Green Hill Solar Farm

EN010170

The Applicant's Cover Letter for Responses to the Secretary of State's First Request for Information

Document Reference: DEC/GH8.1.54

Figure 2: Excerpt from the Construction Code of Practice – Topsoil Stripping³

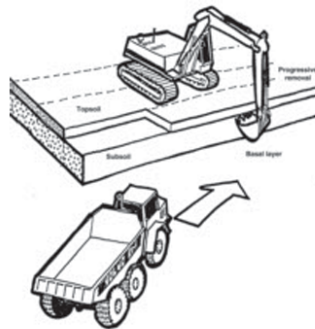
5. The Applicant is requested to provide further justification for concluding that approximately 4.3ha of land under the substation and BESS can be satisfactorily restored to its former Agricultural Land Classification ("ALC") Grade following 60 years under concrete hard standings.

Topsoil and subsoil stripping across different soil types (textural groups) will be undertaken to ensure the clean separation of these resources. **Figure 2** is an extract from the Defra Construction Code of Practice for the Sustainable Use of Soils on Construction Sites. A similar approach will be followed for the stripping of subsoil.
